Marinus Link Pty Ltd
PO Box 606 Moonah
Tasmania 7009

Application No: DA 2022/76
Council reference: SP: CF 2920337 & 9296310
Land: Corner of Minna Road and Bass Highway, Heybridge and 22 Minna Road, Heybridge
Proposal: Heybridge Converter Station, Marinus Link

Response to RFI dated 28 July 2022

Response to RFI dated 24 August 2022

Figure 4-1 Zones of theoretical visibility

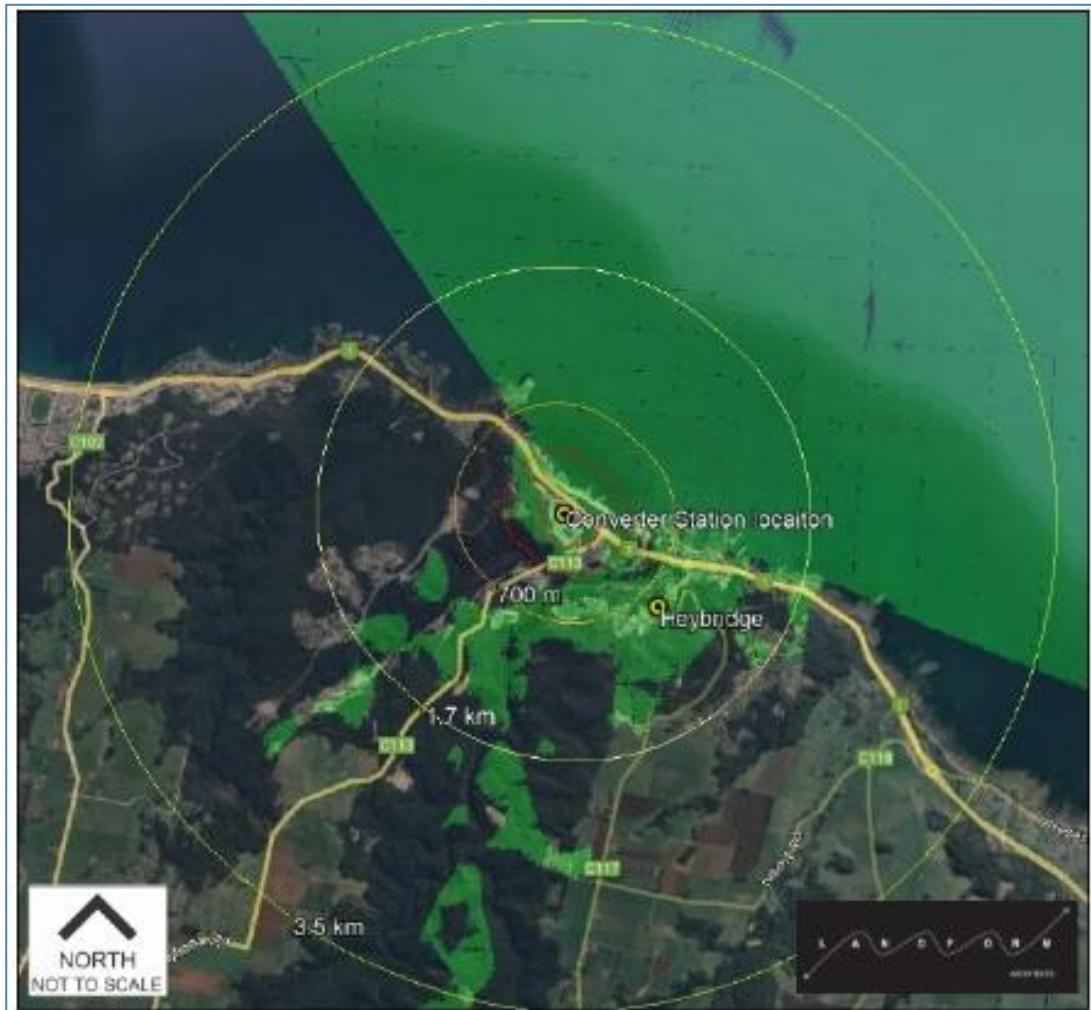
The planning submission notes that a visual impact assessment is being undertaken, but not been provided and that overshadowing plans can be provided. Further information is required to evidence that the proposed apex height of 27 m for two separate buildings does not cause an unreasonable impact on adjoining properties, having regard to the proposed height; the bulk and form of the building; the separation from existing uses on adjoining properties; and any buffers created by natural or other features, in accordance with clause 20.4.1, P1.

The Landscape and Visual Impact Assessment assesses further than immediately adjoining properties. The proposal includes the combined valve, phase reactor and HVDC halls, with a proposed overall height of 27 m above ground level. The study area for the Landscape and Visual Impact Assessment was established based on the height of the combined halls and the parameters of the human vision (i.e. area within 3.5 km of the combined halls). Beyond this distance, the proposal includes a very small element in view and is considered visually insignificant.

Figure 8-1 from the Landscape and Visual Impact Assessment shows the locations from the areas surrounding the proposal site that have the potential to see the proposal, in this case the top of the converter station buildings (i.e. Zones of Theoretical Visibility (ZTV)). There are limited publicly accessible locations beyond 1.7 km where the converter station would be visible.

It is unlikely there will be overshadowing impacts to residences surrounding the proposal site. The nearest residences of Crown Circuit are the closest to the Phase Reactor Hall at over 250 m. As such, overshadowing plans are not proposed at this stage.

Figure 6-1 Proposed Heybridge Converter Station conceptual site plan, with parking spaces marked up in red (See Attachment 2)

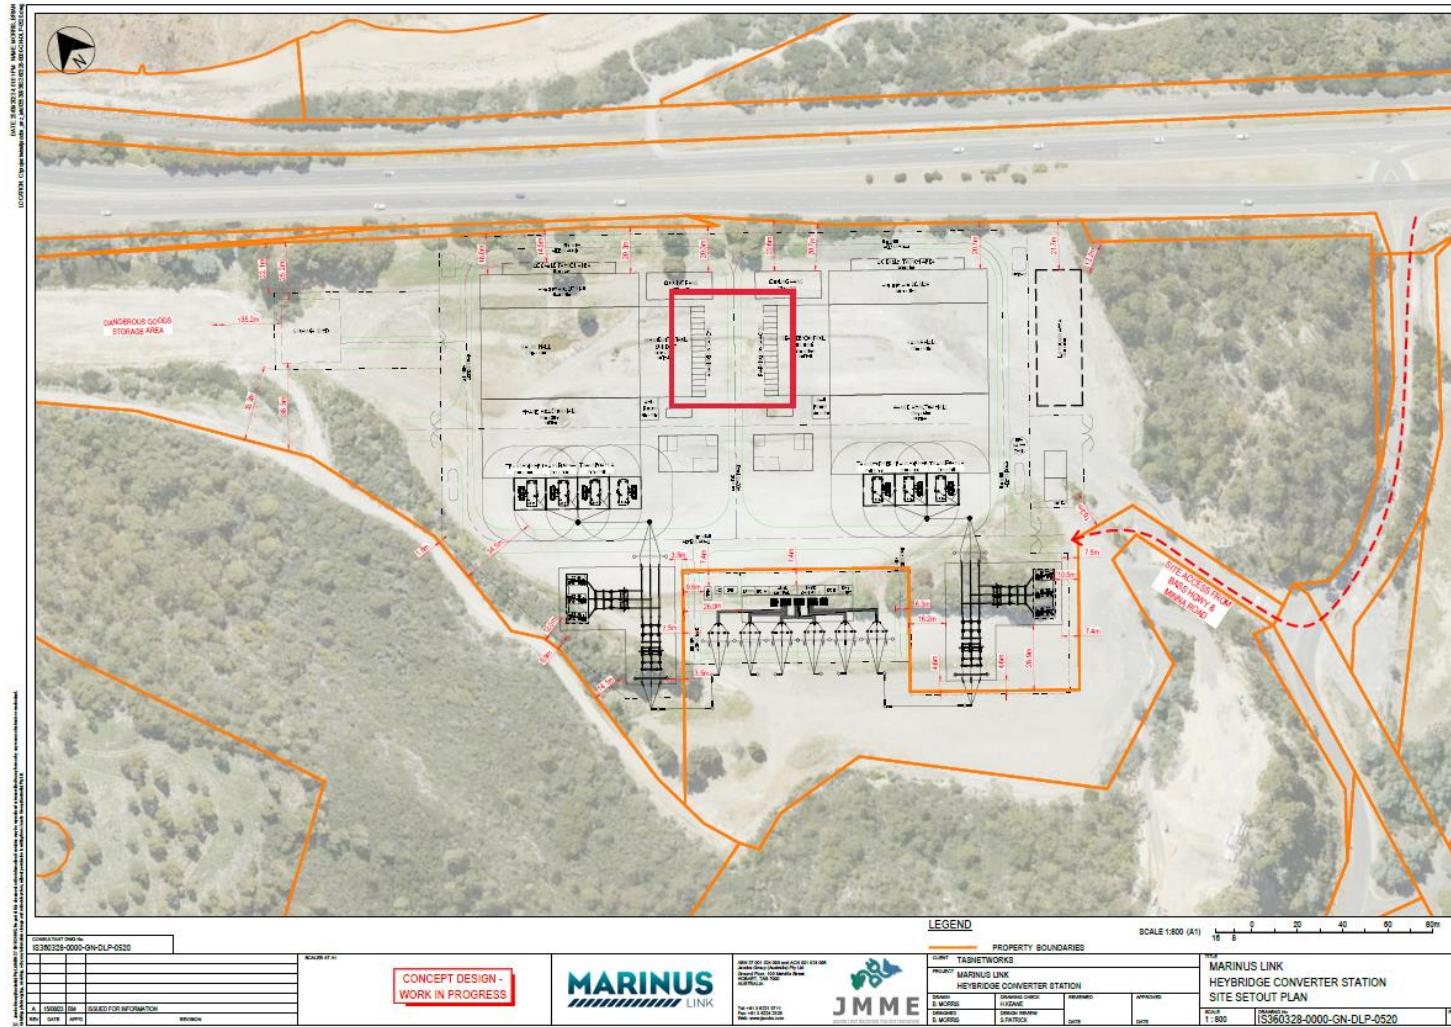
It is noted that there is no minimum requirement for onsite parking for a Utilities use class. However, as onsite parking is proposed can you please provide a parking plan, which details compliance with clauses C2.6.1 and C2.6.2.

The proposed parking area would be designed to be compliant with C2.6.1 (Construction of parking areas) and C2.6.2 (Design and layout of parking areas) and as shown on the conceptual site plan provided in Figure 6-1 and **Attachment 2**.

CONSULTANT DWG No:
IS360328-0000-GN-DLP-0520

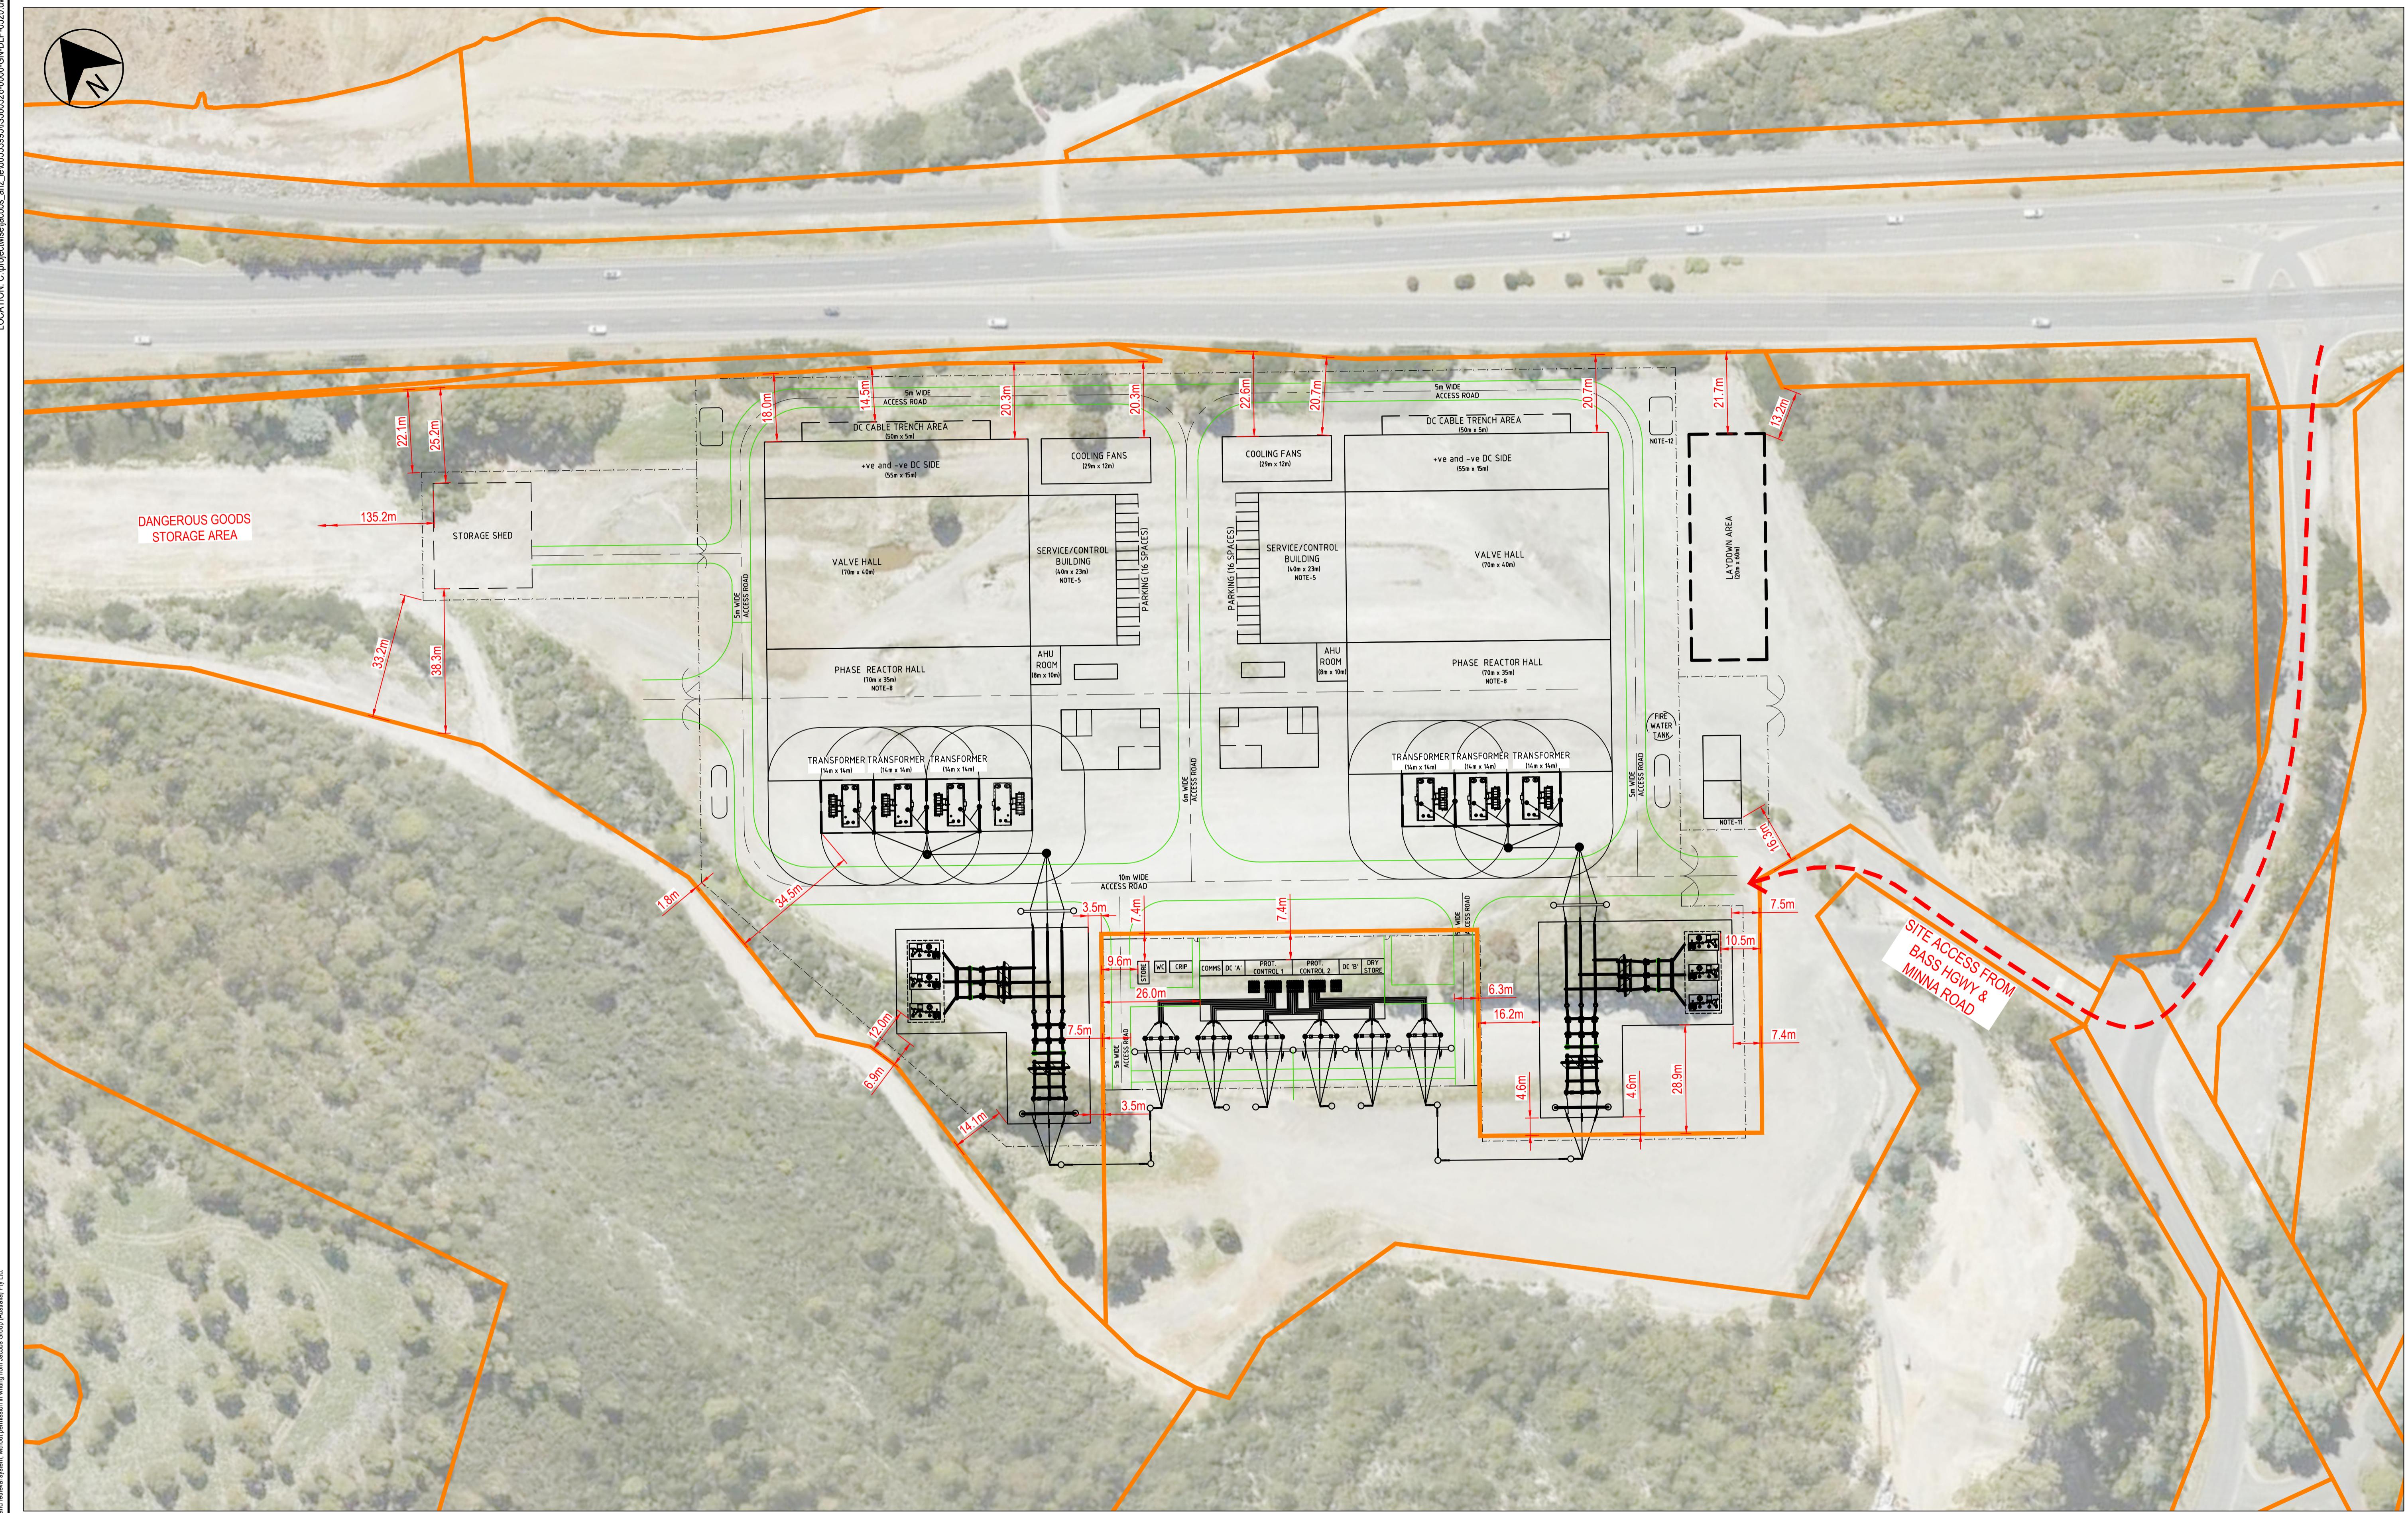
Council RFI	Response to RFI
<p>Please provide a site plan clearly showing the setback distances from the proposed buildings to all boundaries.</p> <p>Further, please provide fully dimensioned elevations of all the proposed buildings.</p>	<p>A conceptual site plan with setback distances outlined from the proposed infrastructure to boundaries, and the elevations of proposed buildings are provided in Attachment 2.</p>

Figure 12
Planning Scheme Zones

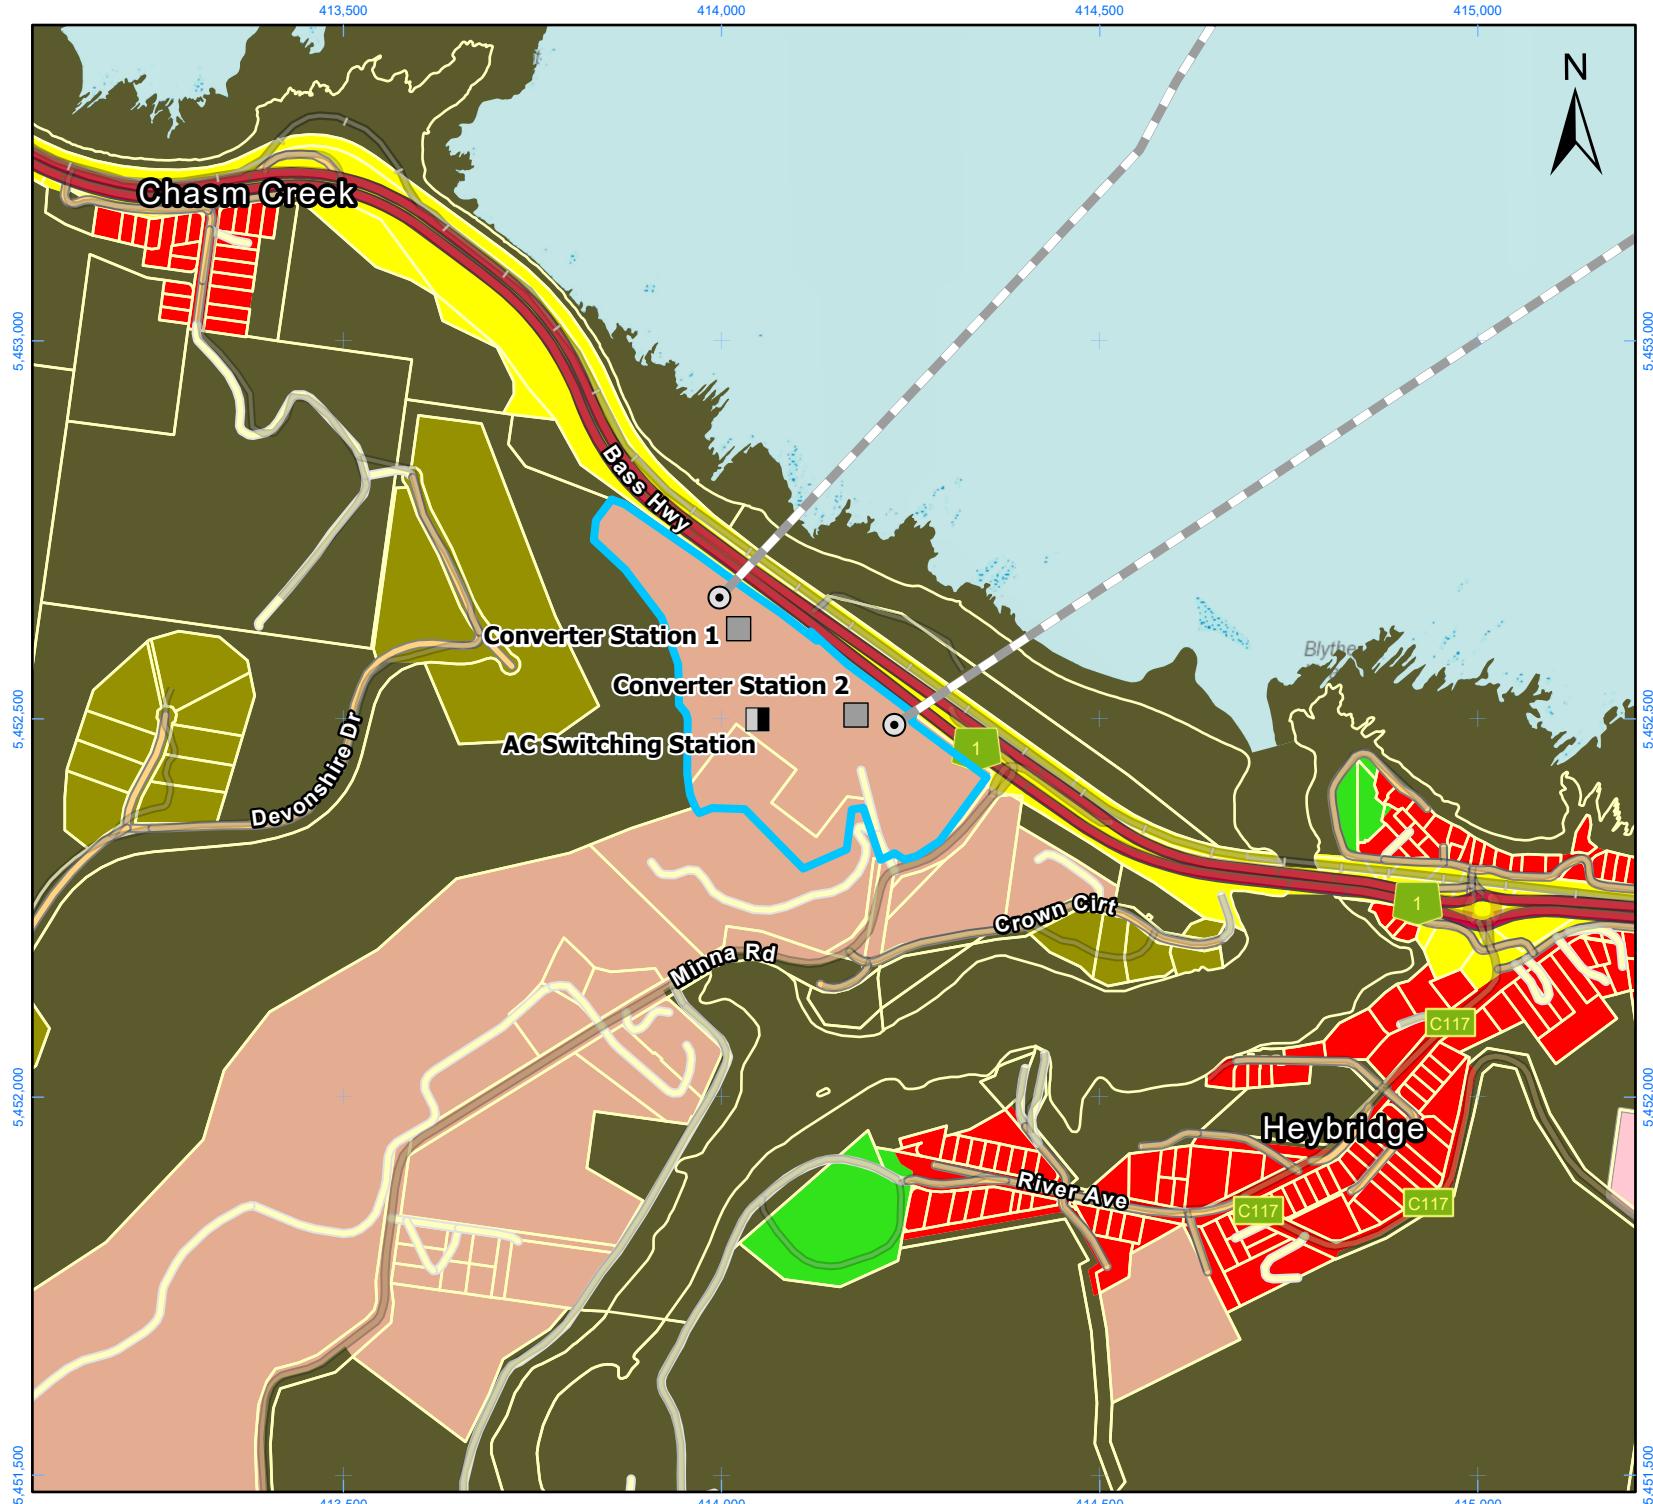
Council RFI	Response to RFI
<p>We note that on page 42 of the planning submission, refers to old zones referencing the previous planning scheme (Burnie Interim Planning Scheme), which needs to be updated to current zones under the Tasmanian Planning Scheme.</p>	<p>Figure 12 of the Development Application (2022/76) has been updated to reflect the current zones under the Tasmanian Planning Scheme. This Figure is provided in Attachment 3.</p>
